**ON-SITE SEWAGE DISPOSAL SYSTEM
 HOWARD COUNTY HEALTH DEPARTMENT
 BUREAU OF ENVIRONMENTAL HEALTH**

SUBDIVISION: Foxtail Run LOT NUMBER: 5

ADDRESS: 13716 Greyfox Run PROPERTY OWNER: Rylea Homes, Inc.

LOCATION DRAWING
LOT 5
FOXTAIL RUN

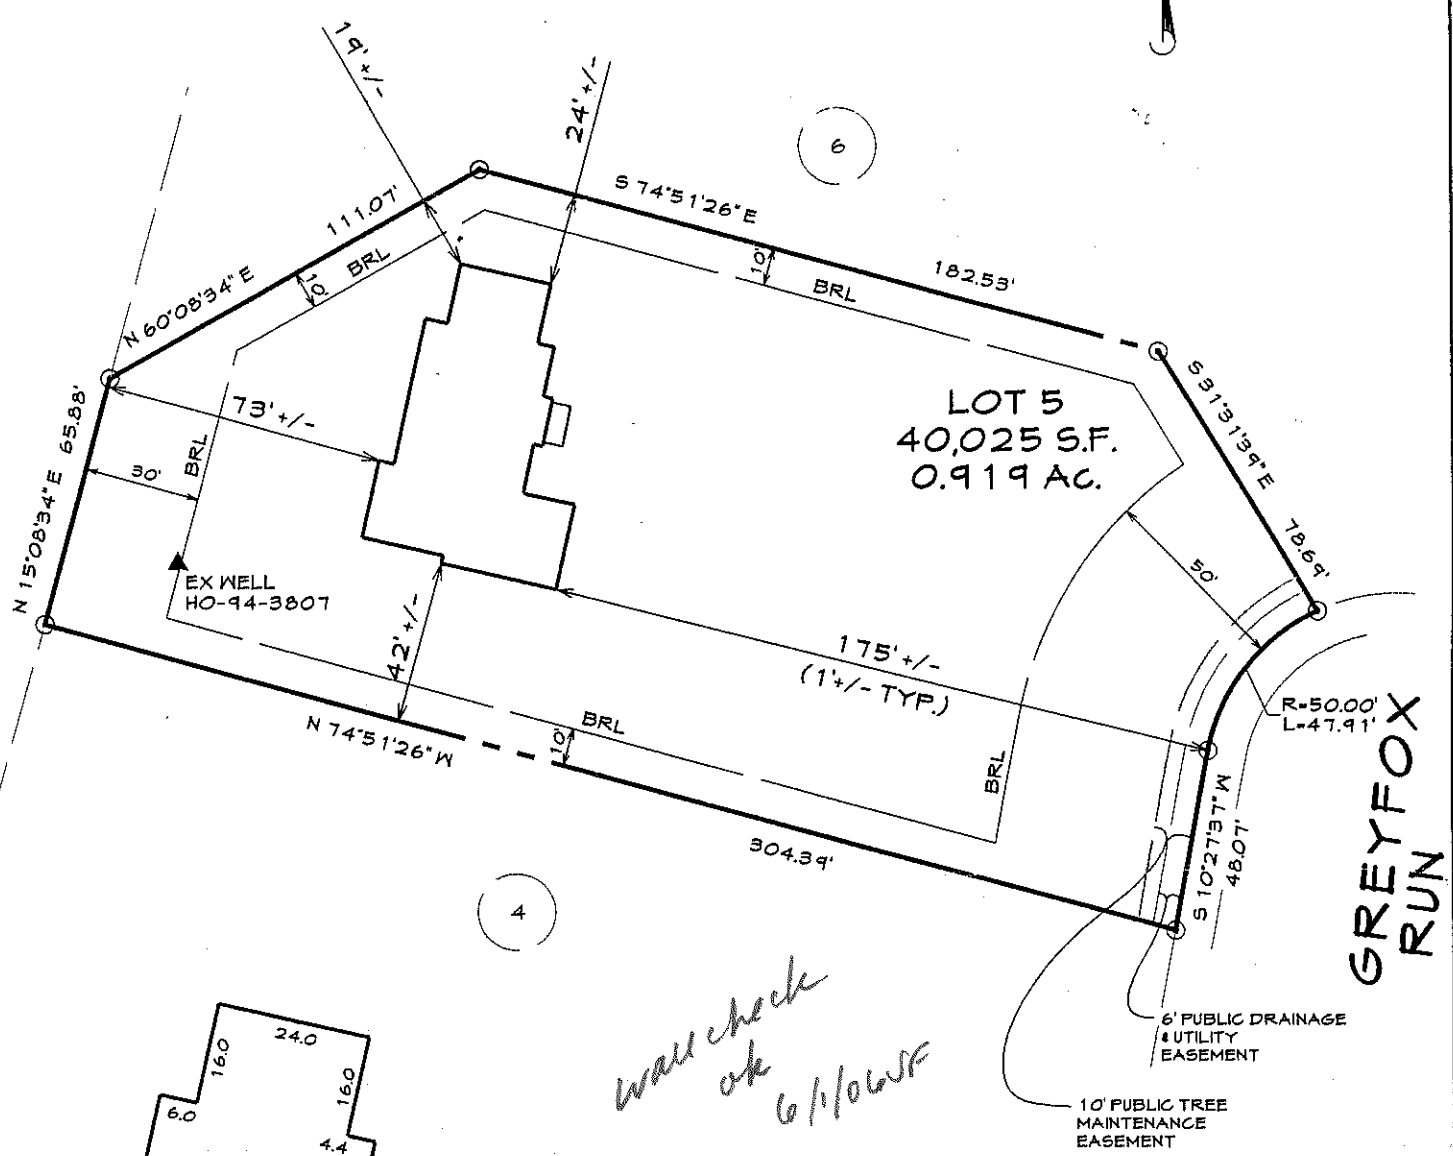
6/8/06 Trench inlet depth changed to improve use of septic easement. (BB)

6/13/06 System installed. 90' trench was put in somewhat off contour. This was done by contractor in order to save repair area. O.K. to backfill (BB)
